**CITY OF NAPOLEON
BUILDING CONSTRUCTION PERMIT
(1, 2 or 3 Family Dwelling)**

Zoning "C" Intended use of Building: Converting existing detached garage flat roof to 6/12 slope gable roof. Also installing wood siding, windows and doors to existing garage only.

CITY OF NAPOLEON
ENGINEERING DEPT.
PLAN APPROVAL
BY: PLP DATE: 5/14/75

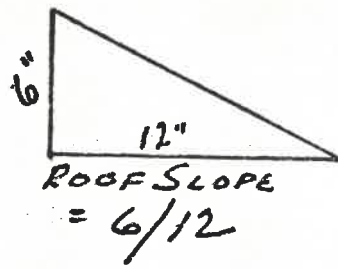
Comments: 5/2 informed Wilbur existing bearing partitions must be 16 5/8" with vertical studs PWP

- 1) Provide min 22' X 30' access opening to new attic area, Sec. R-700 of B.O.C.A.
- 2) No Storage permitted in attic area because of span of ceiling Joist.
